SYSTEM CHECK, BRP ENGINES

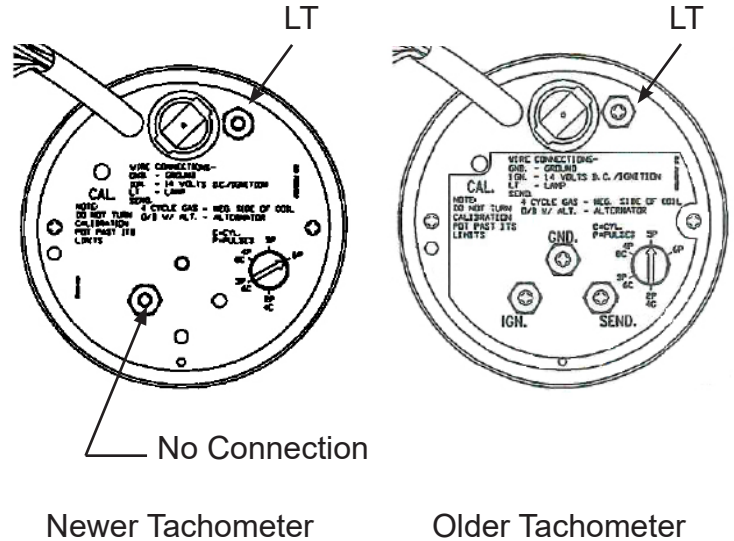
In late 2000, Teleflex engineering team re-designed the BRP System Check tachometer and removed the requirement to have separate power (IGN), ground (GND), and tachometer signal (SEND) from the back of the BRP System Check tachometer. The new BRP System Check tachometer receives all the information and power through the harness.

If you are replacing an older tachometer with a new one and have extra wires for power, ground, and tachometer signal, these connections are no longer necessary on the new tachometer. There is a stud on the back of the new tachometer in the same place as the old IGN (power) stud but no electrical connection should be made on this stud. The only connection which need to be made in addition to the plug is the power for the light (LT).
